Wayland Town Center

RE: Wayland Town Center Meeting, Oct 22 2007

RE: Master Special Permit Application Town Center Project 400 Boston Post Road

RE: Traffic Engineering Peer Review – Proposed Town Center Project

Monument Revision scale: 1/4" = 1'-0"

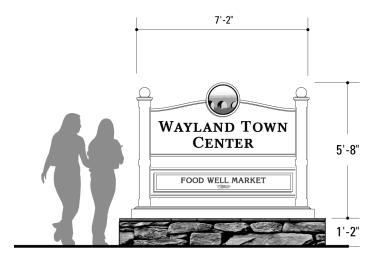
- "MSP Signage Summary," dated 23 October 2007.
- "Monument Revisions," dated 11 October 2007, showing the final design for the Route 20 and Route 27 monument entry signs.
- "Wayland Sign Package," dated 23 October 2007, reflecting the final design for the other on-site way-finding signs, including the Vehicular Directional signs, the Directory Signs, the Pedestrian Directional Signs, the Access Signs and the Residential Entrance Signs.

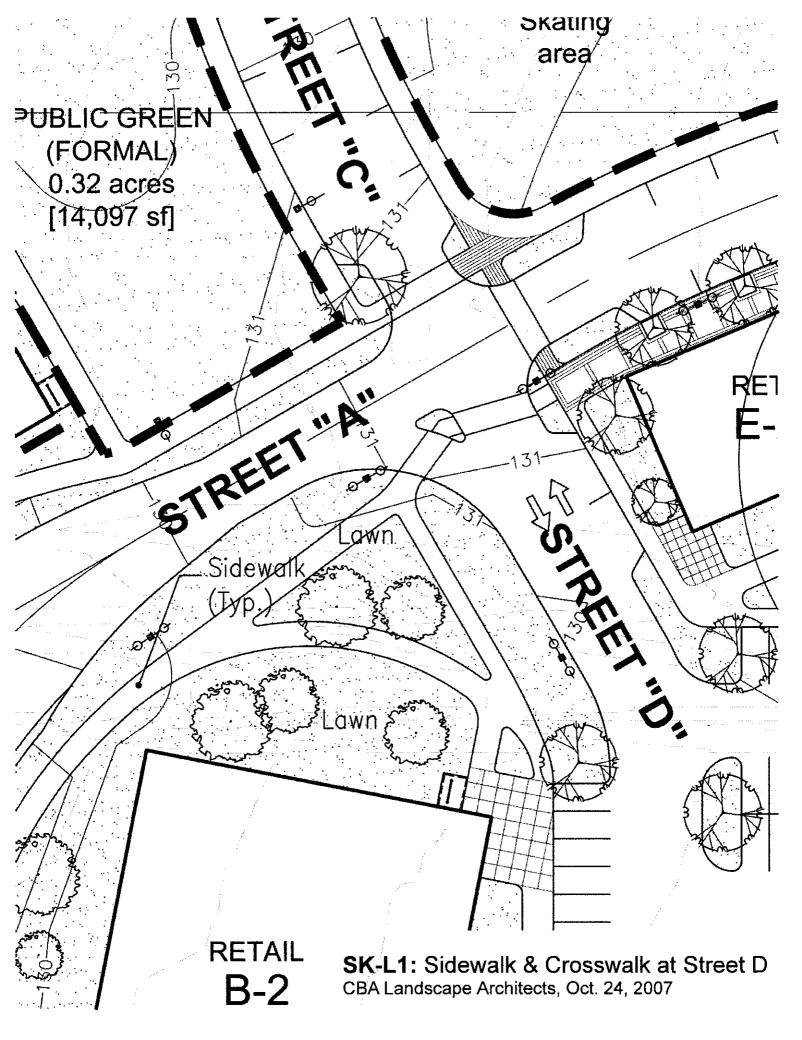
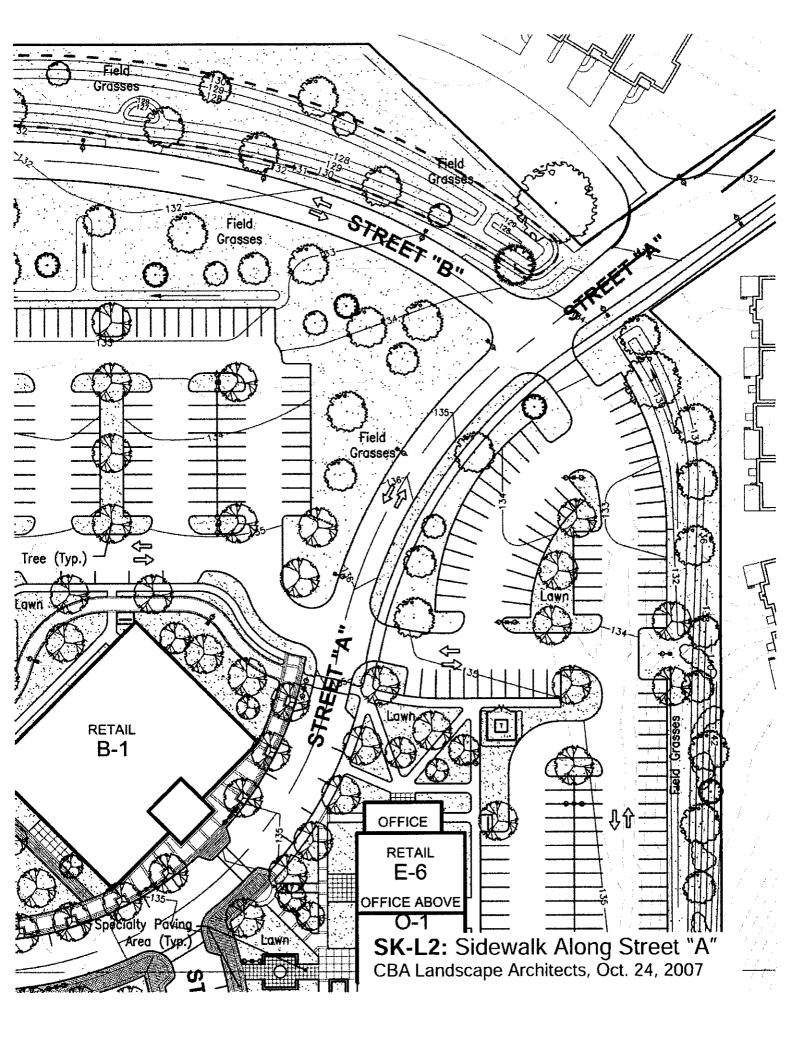
Sketch SK-L1 addresses the concern raised by TEC in their memorandum of October 15, 2007, item 2, regarding the location of the crosswalk accessed by the sidewalk entering the site from Route 20 in the area between buildings B-2 and E-24. The sketch represents the first draft of a redesign of the area, which will be further refined during the site plan review phase to address any remaining concerns of the Planning Board and the Town's consultants.

Sketch SK-L2 addresses the concern raised by TEC in their memorandum of October 15, 2007, item 6, regarding the sidewalk and crosswalks along Street "A" between the commercial area and the Route 27 entry, particularly the relocation of the sidewalk to the south side of the street. The sketch represents the first draft of a redesign of the area, which will be further refined during the site plan review phase to address any remaining concerns of the Planning Board and the Town's consultants.
